GENERAL INFORMATION

Request: 1) Preliminary development plans for a partial redevelopment at the Clover Center shopping center with future retail and mixed use development phases.
2) Final development plans for a partial redevelopment of Clover Center to accommodate an approximately 24,000 square foot grocery store and reconstructed parking lot.

PROPOSAL

Case PL2021-191

Graphic 1: Rezoning to Apply the Planned Development (PD) Overlay

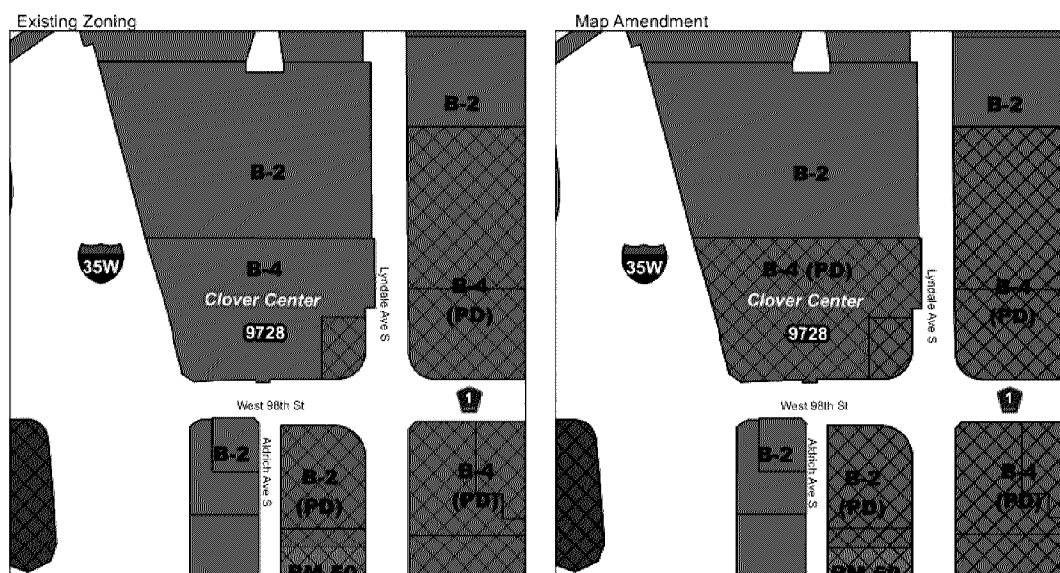
The "base" zoning district, B-4, would remain the same with the proposed rezoning; the applicant is seeking to apply the PD Overlay Zoning District to the site, which allows the City Council to approve the deviations from City Code. The permitted and conditional uses along with the development intensity and mixed-use district development standards would remain in place. Graphic 1 depicts the zoning map amendment.
